The Corporation of the District of Saanich

## Supplemental Report 2

**To: Mayor and Council**  
**From: Sharon Hvozdanski, Director of Planning**  
**Date: September 9, 2021**  
**Subject: Rezoning and Development Permit Amendment Application**  
**File: REZ00605; DPA00931; DPA00959 • 3956 Shelbourne Street**

Figure 1: Proposed Home Depot Expansion –Site Plan (provided by Kubik Developments Corp)

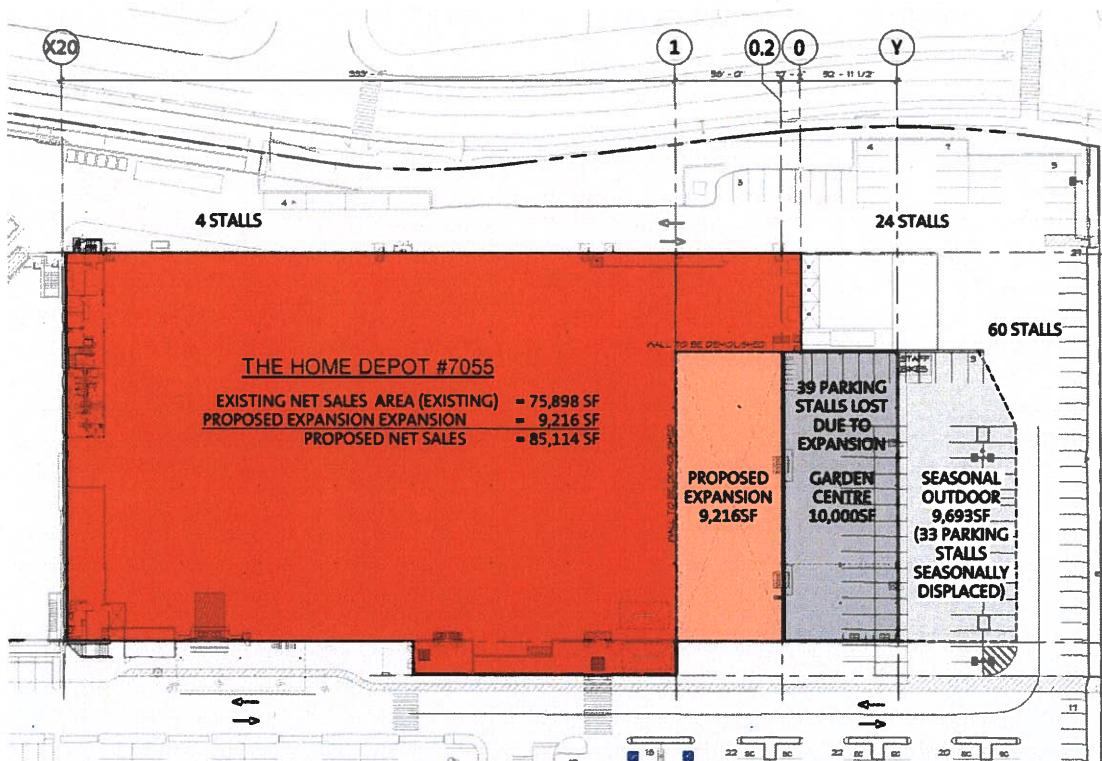
Since Council last considered the proposed development application, significant revisions have been made through the proposed expansion to the Home Depot Store. The proposed work includes an 856 m<sup>2</sup> addition to the existing Home Depot in the location of the existing Garden Centre. A new Garden Centre would be located north of the proposed addition and a Seasonal Outdoor Area is proposed north of the Garden Centre (see Figure 1). The operation of the Seasonal Outdoor retail area would be limited to: mid-March through to mid-September; and November 23 to December 25 to allow for Christmas trees sales. This seasonal outdoor retail period has been expanded from the existing operational period currently in place and included in the Development Permit registered on the property. Staff recommend that these time limited operational periods be secured by covenant and note that the applicant is supportive of this expanded operational period.

The proposed addition to the Home Depot would increase the commercial floor area, as well as, displace existing commercial parking. As a consequence, a greater parking variance for the site is being proposed. Variances are discussed in more detail later in this report.

Figure 2: Proposed Building D's Ground Floor Plan (provided by WA architecture)

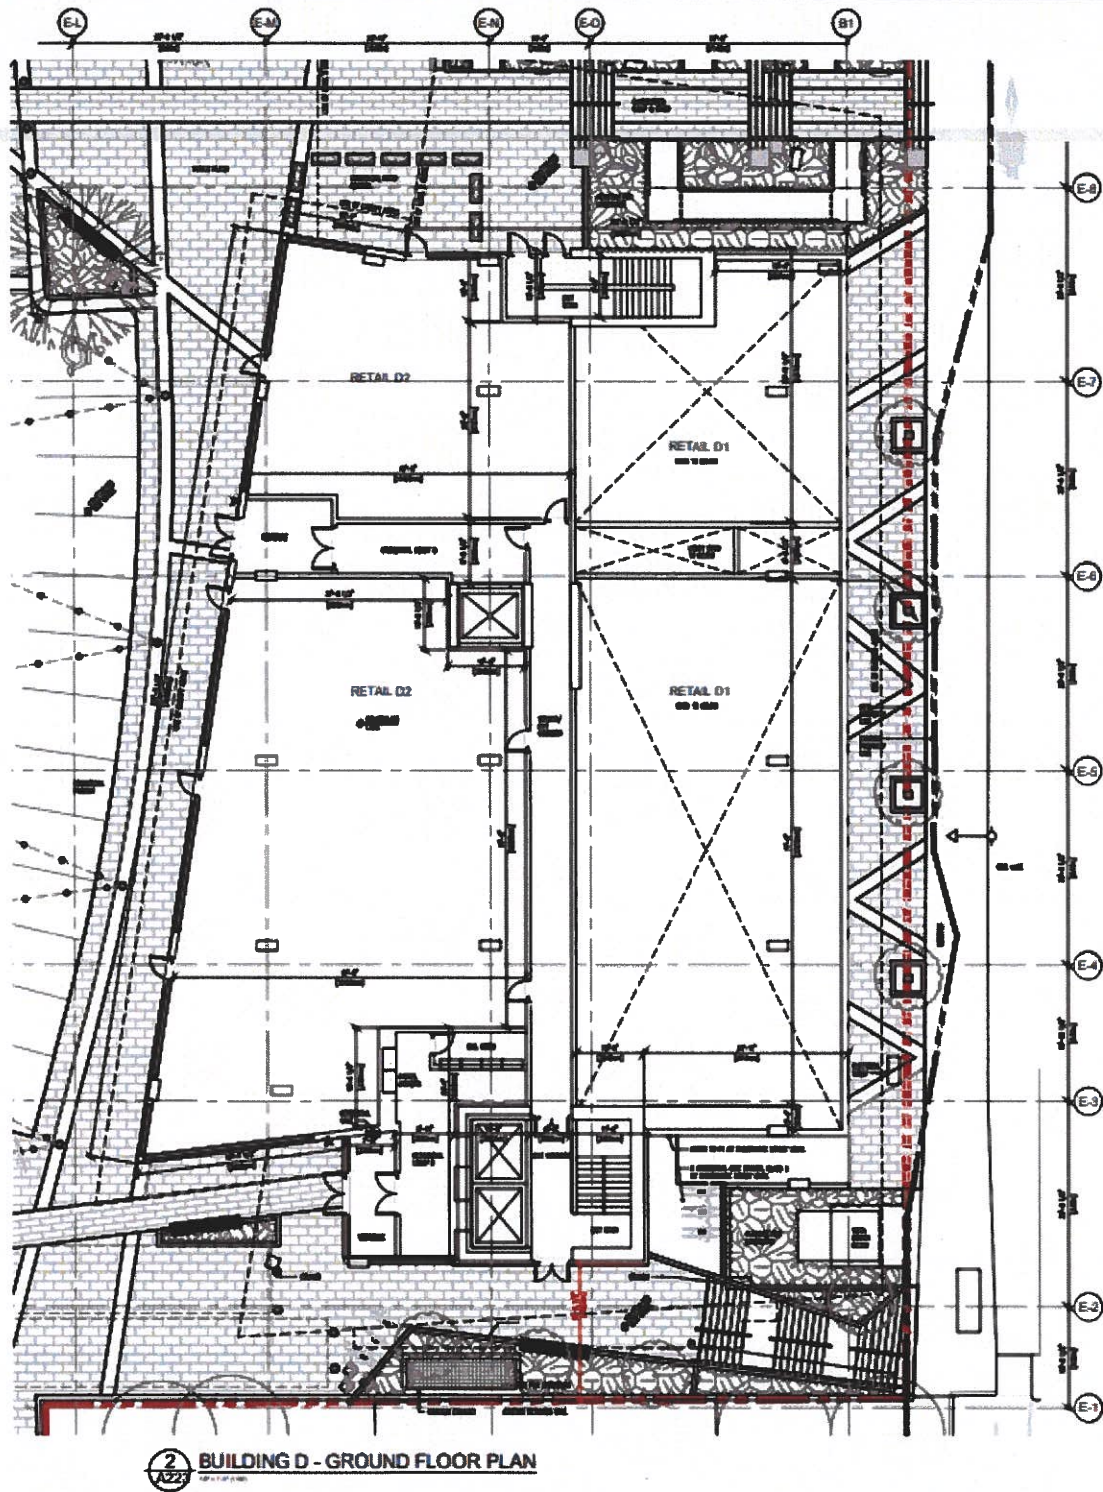
The revised application proposes to relocate the commercial lobby and elevator from the north elevation to the west elevation fronting the internal 'High Street'. On the Shelbourne Street elevation, the lobby access has also been relocated which allows for additional commercial frontage at the north east corner of the building. The below grade and residential floors above have been revised to accommodate the ground floor changes described above.

Figure 3: Proposed Temporary Loading Ramp (provided by WA architecture)

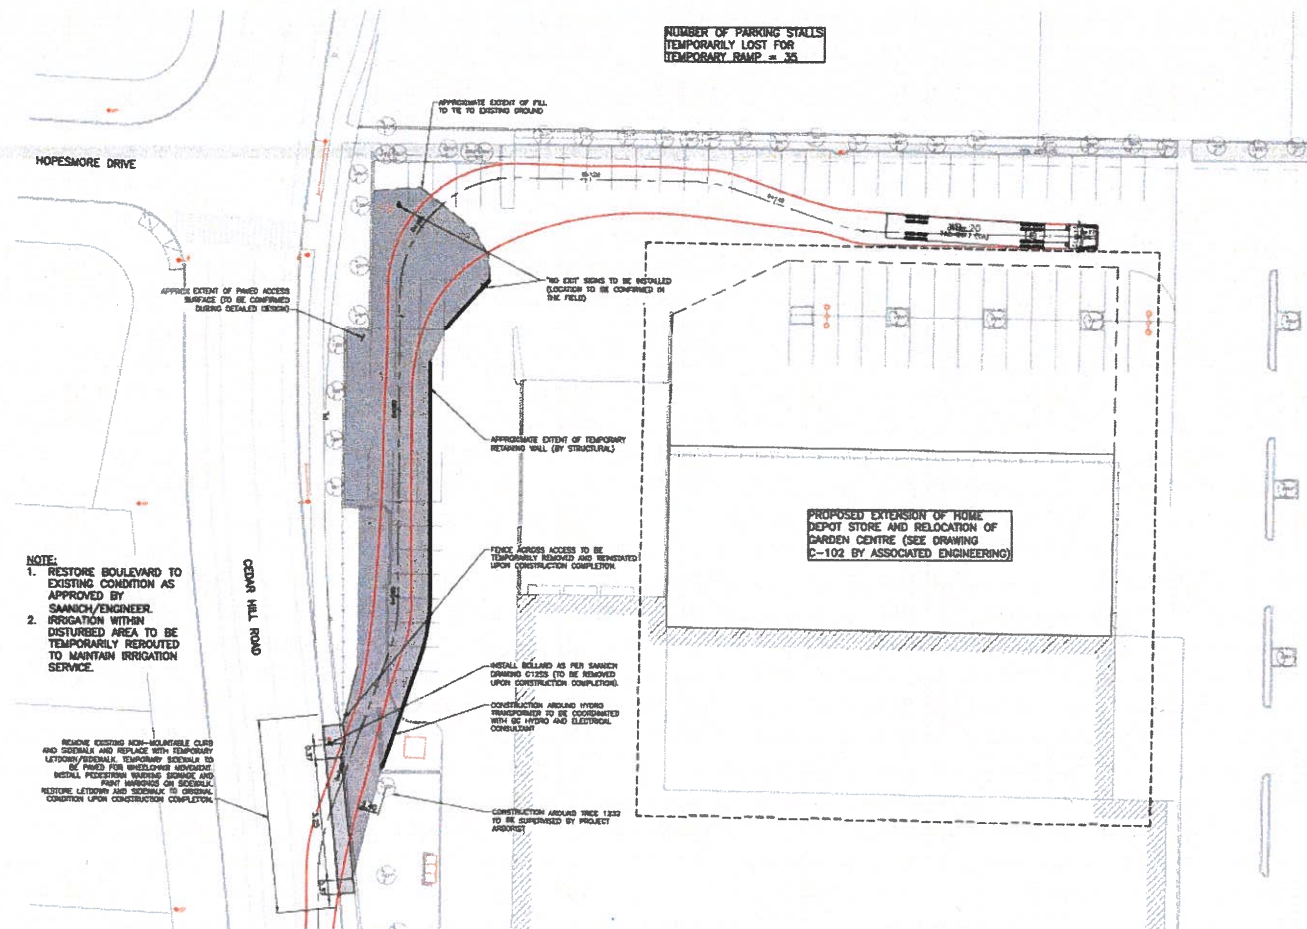
To avoid disruption of Home Depot's business operations during the construction of the primary development proposed for Development Area A, a temporary loading ramp is proposed to allow loading access to the Home Depot loading bay from Cedar Hill Road.

The design of the proposed temporary loading ramp has been revised as per Figure 3 below. The temporary ramp would displace 35 commercial parking stalls. Should Council see merit in the proposed development application, and when construction of the project is complete, the temporary loading ramp would be removed and the boulevard and parking stalls would be reinstated consistent with proposed works for DPA00931. The temporary nature of the ramp is proposed to be secured by covenant which would be limited to a five year period.

Figure 4: C-3UH Zoning Diagram

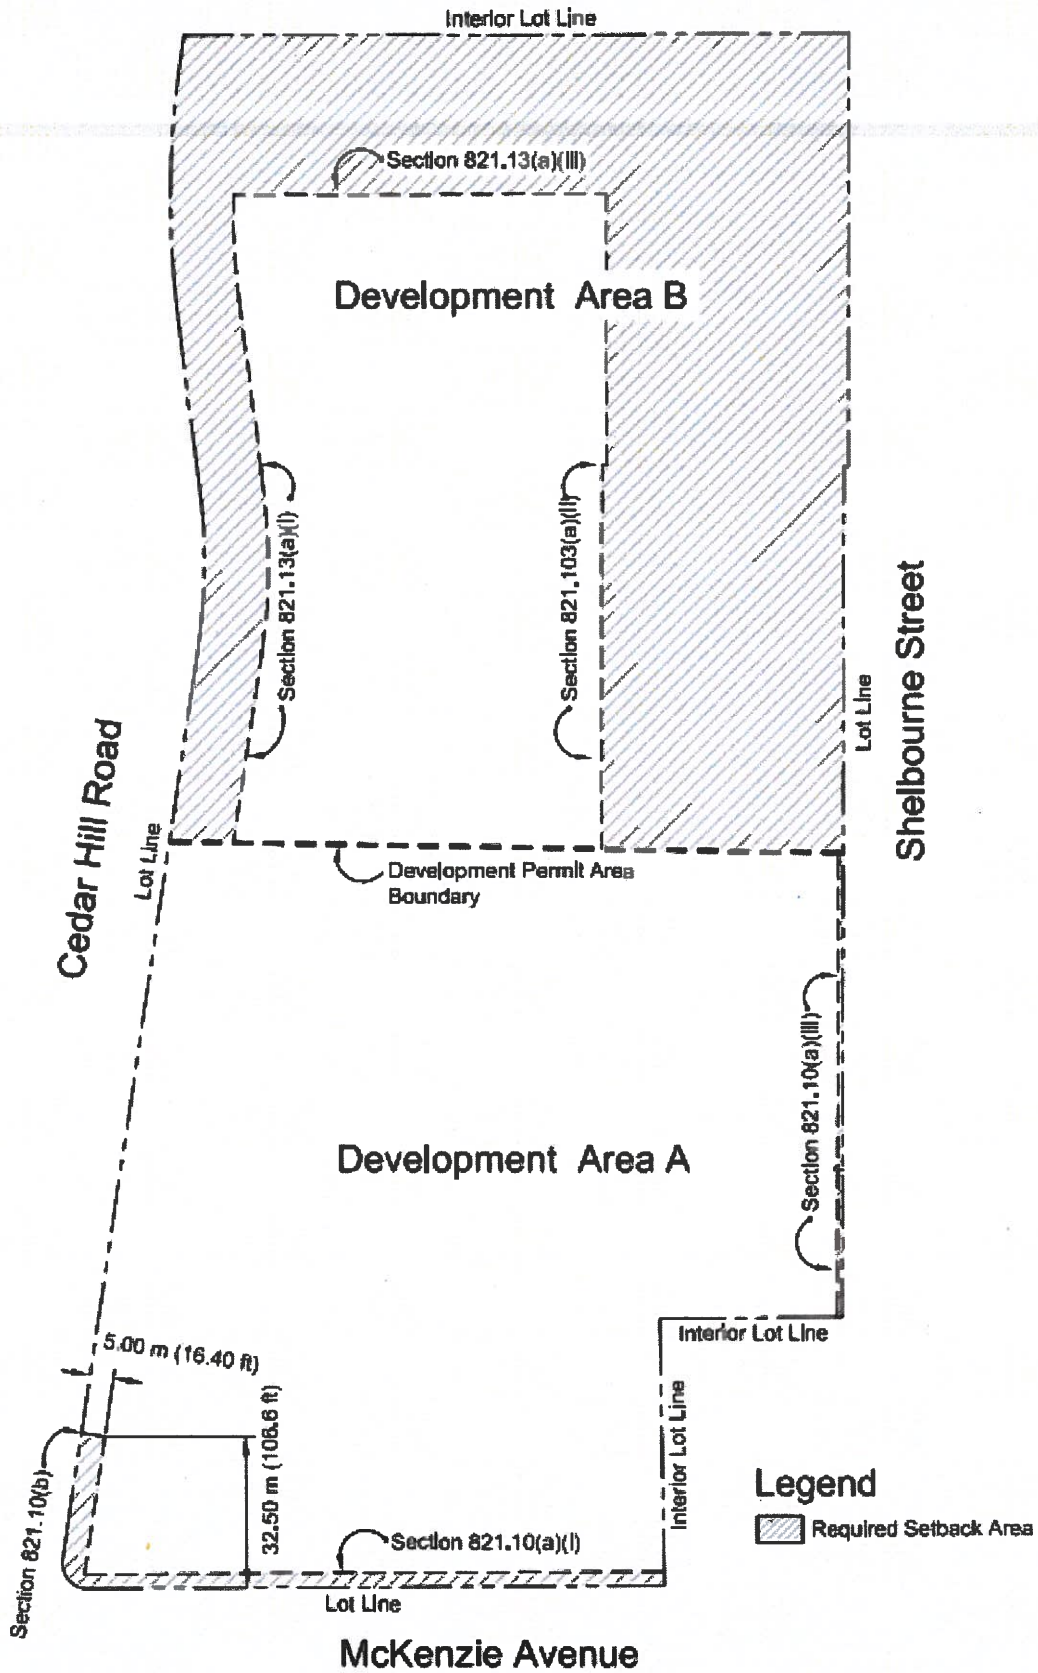
The applicant has requested a rezoning to a new site-specific C-3UH (Shopping Centre University Heights) Zone. The new zone would include the same permitted uses as the current C-3 (Shopping Centre) Zone. The C-3UH Zone has been revised to accommodate the most recent development proposal to include two Development Areas (see Figure 4).

Development Area A (DA-A) would include the site south of the southern face of the Home Depot and is proposed to regulate the primary development. DA-A would permit a 2.12 Floor Space Ratio (FSR) and limits the number of dwelling units to the proposed 597. The new zone would allow a maximum building height of 66 m measured from sea level (approximately 31.0 m measured from grade) whereas the C-3 Zone permits a maximum height of 15.0 m measured from grade.

Development Area B (DA-B) would include the site north of the southern face of the Home Depot and is proposed to regulate the Home Depot portion of the site. DA-B would permit a 0.39 Floor Space Ratio (FSR), which allows for the proposed expansion to the Home Depot, and prohibits dwelling units. The proposed increased required setbacks are to wrap the existing and proposed area and location of the Home Depot. The maximum building height permitted would be 40.84 m measured from sea level, which allows for the one storey commercial development.
